Sacramento County, California

Request for Proposal

Garfield Avenue Transmission Line Replacement Project

Addendum No. 3

**Garfield Ave Transmission Line
Replacement Project - Gibbons Dr**

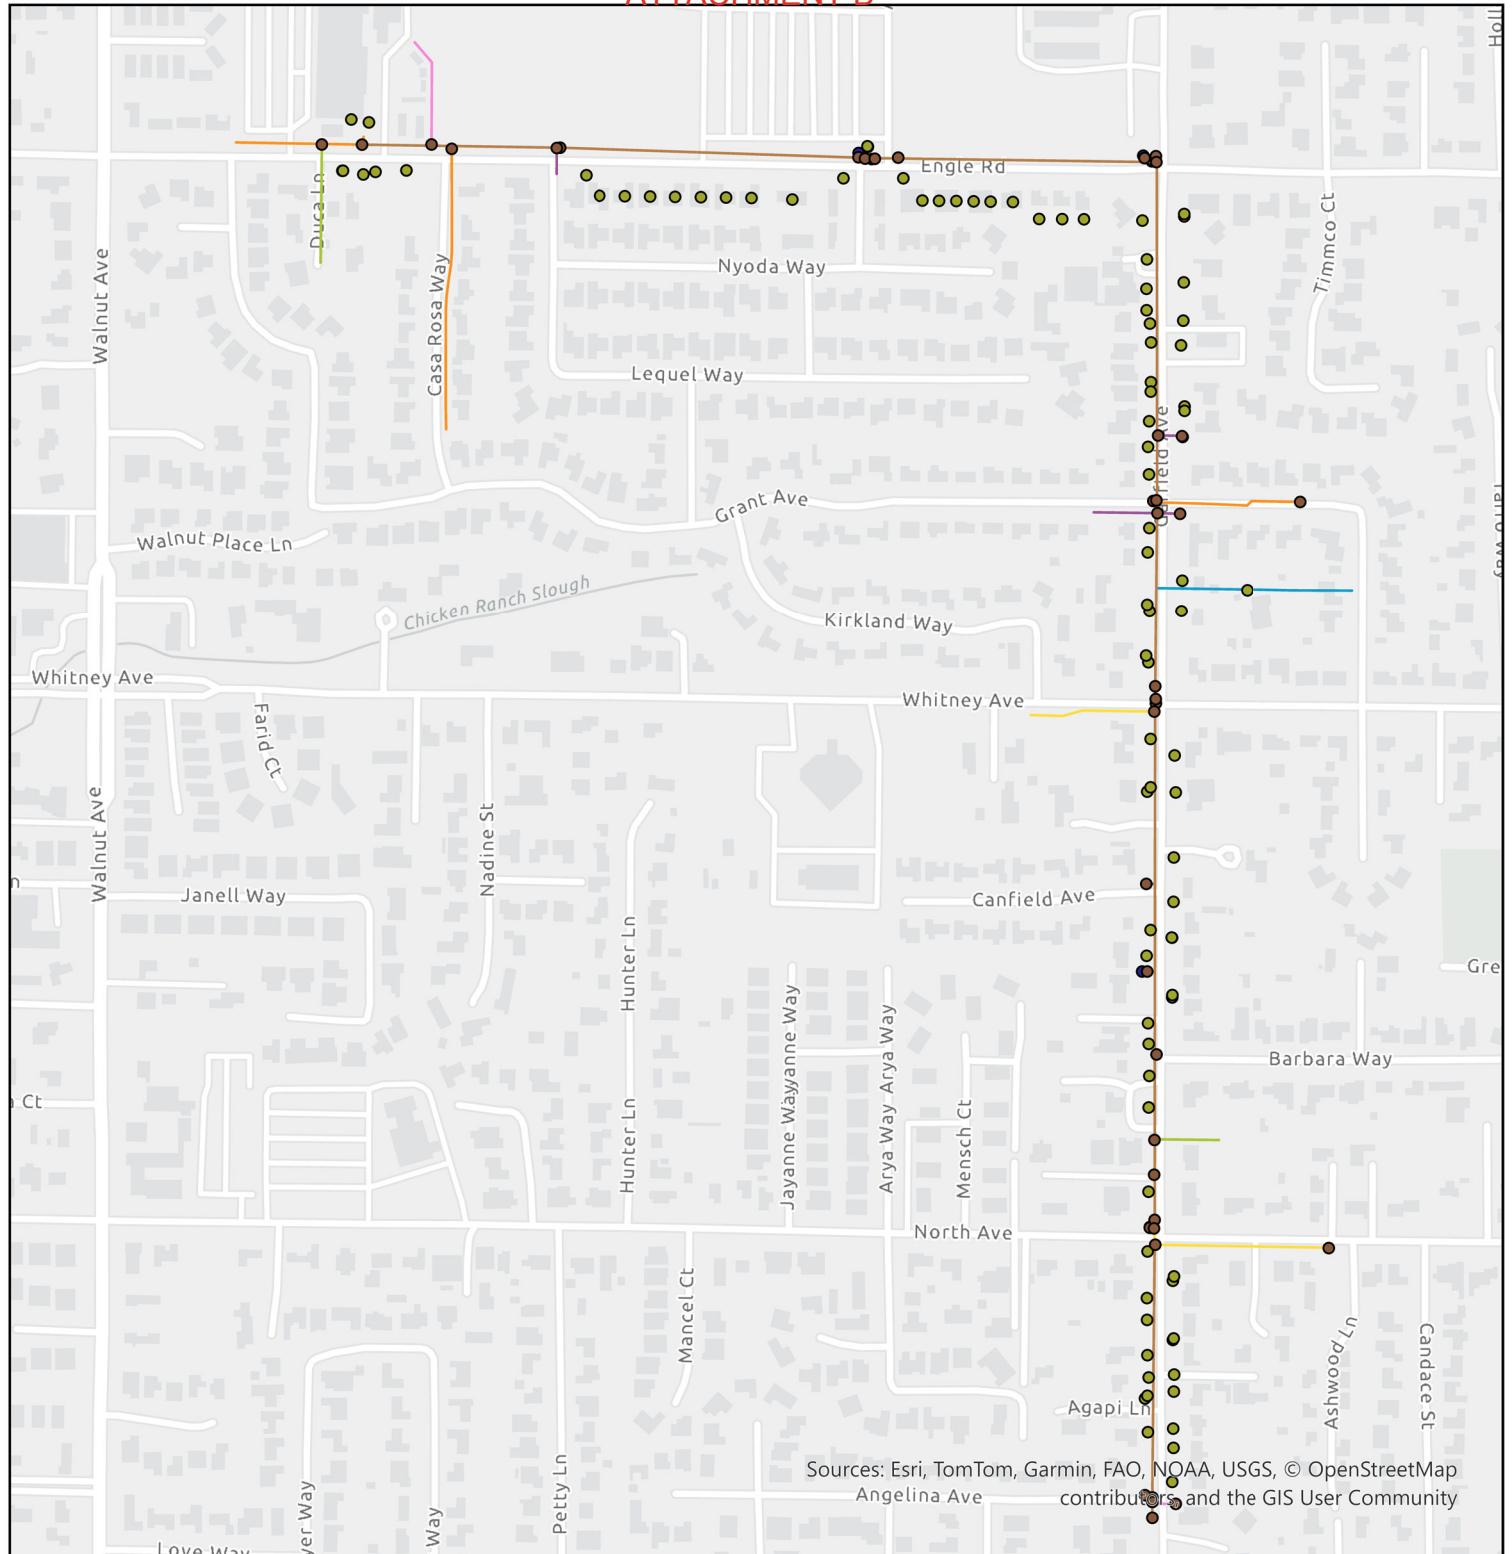
Q1: Would the District please provide their water utility maps for reference?

Q12: The Master Plan notes transmission mains typically lack services. Can you confirm no existing or new service connections will be required on this pipeline?

A1: Please see Attachment A and B maps of the distribution system immediately impacted by the transmission line replacement.

A12: It is typical, but not always, see Attachments A and B to estimate the number of services.

ATTACHMENT C

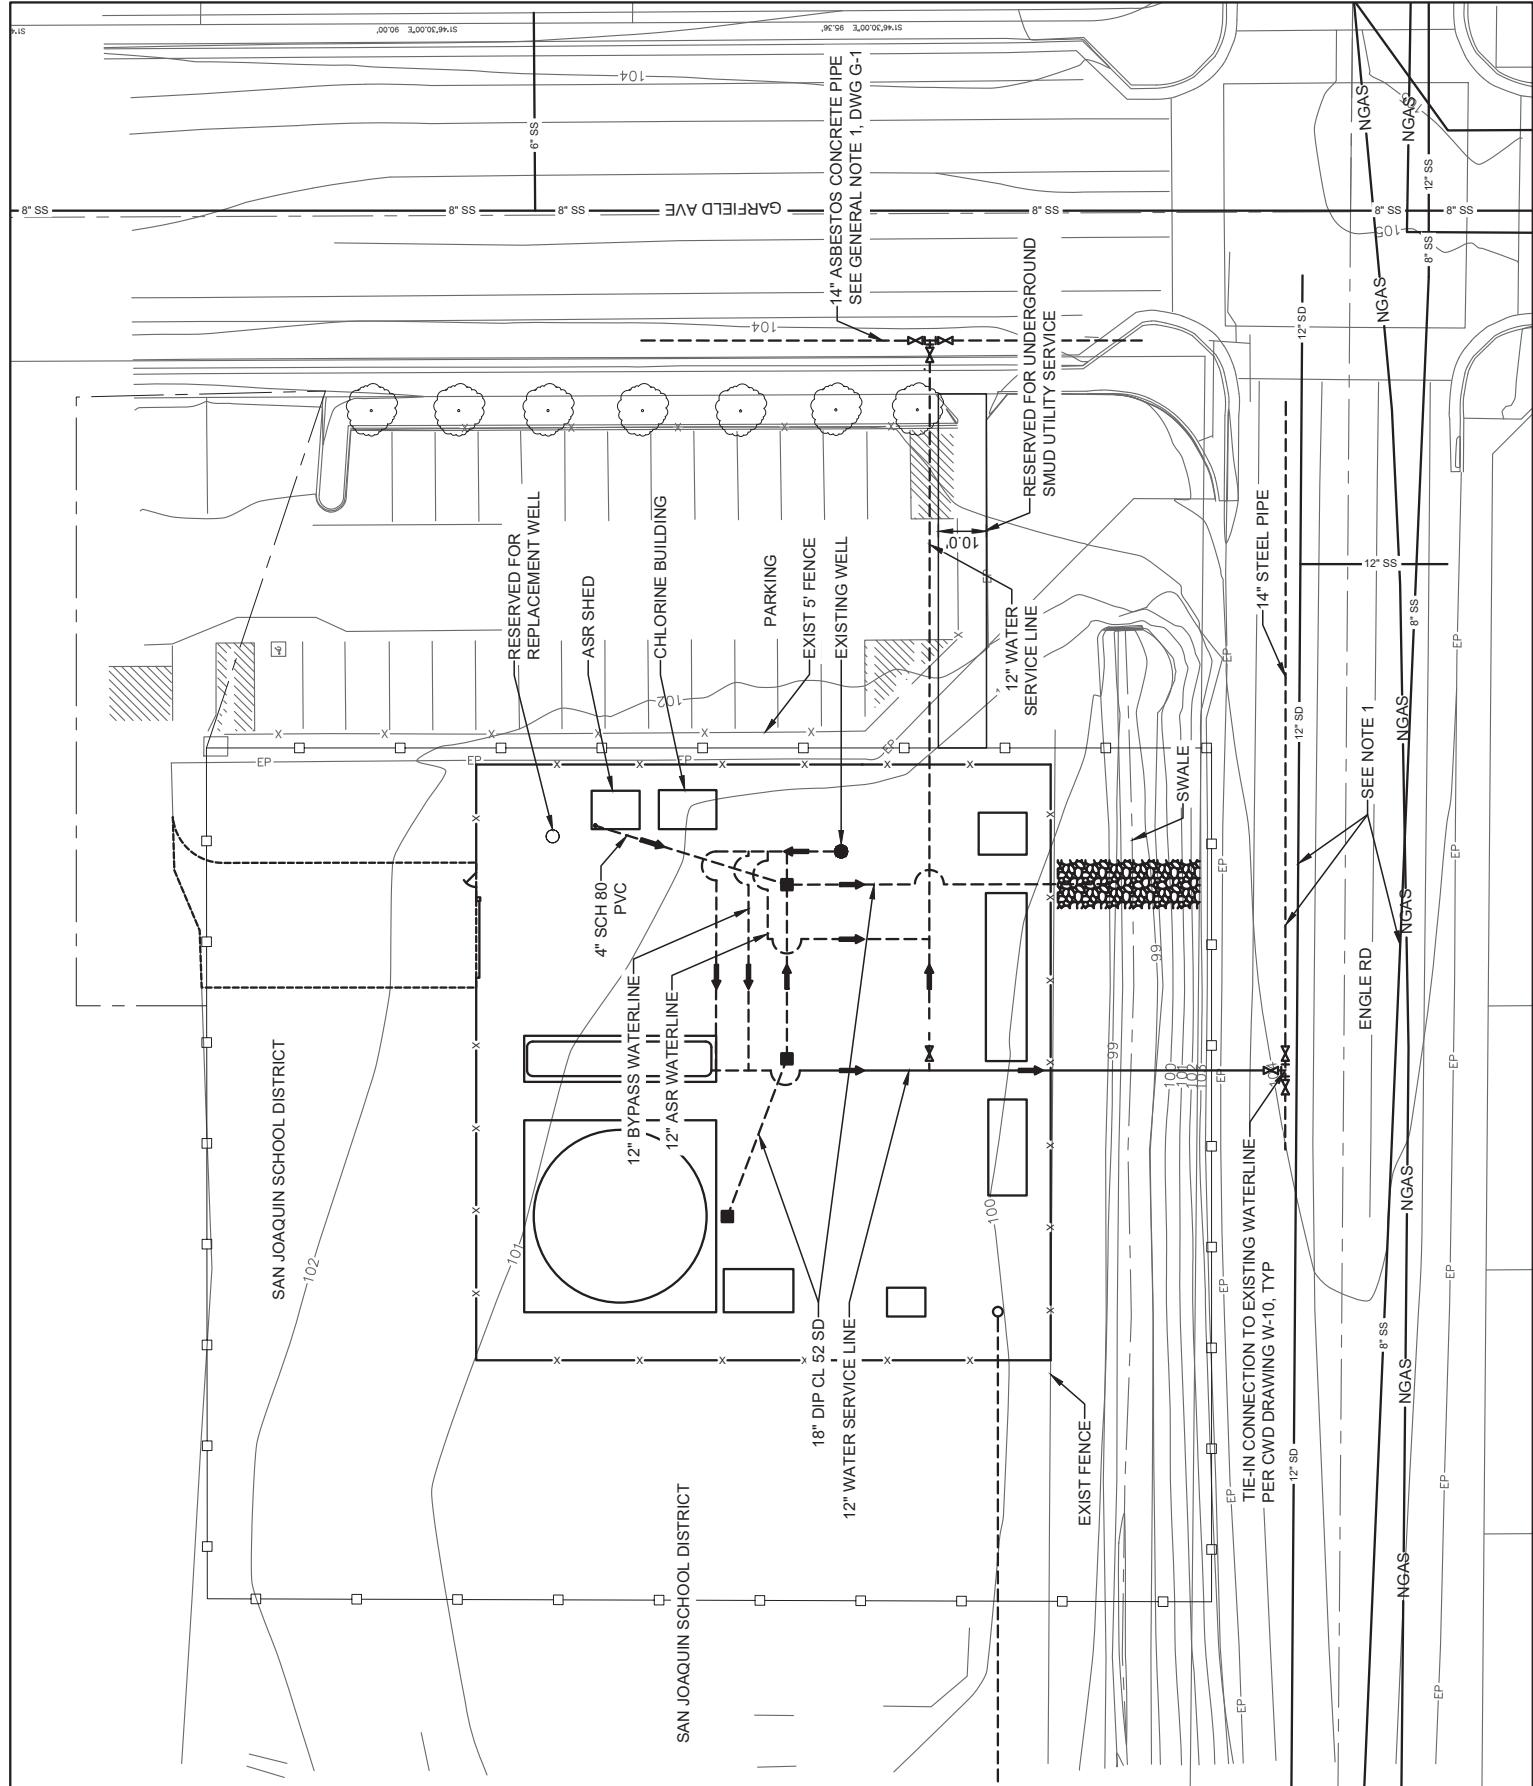
Q2: Have there been other recent District projects in the immediate vicinity that this project will be tying into?

A2: Yes, on Engle Road we just installed a new ASR Well that ties into our distribution system on Engle Road and this tie-in is not shown on our current map. See Attachment C - plan sheet of that tie-in location, the tie-in is actually 12-15 feet East of where it is shown on the plan.
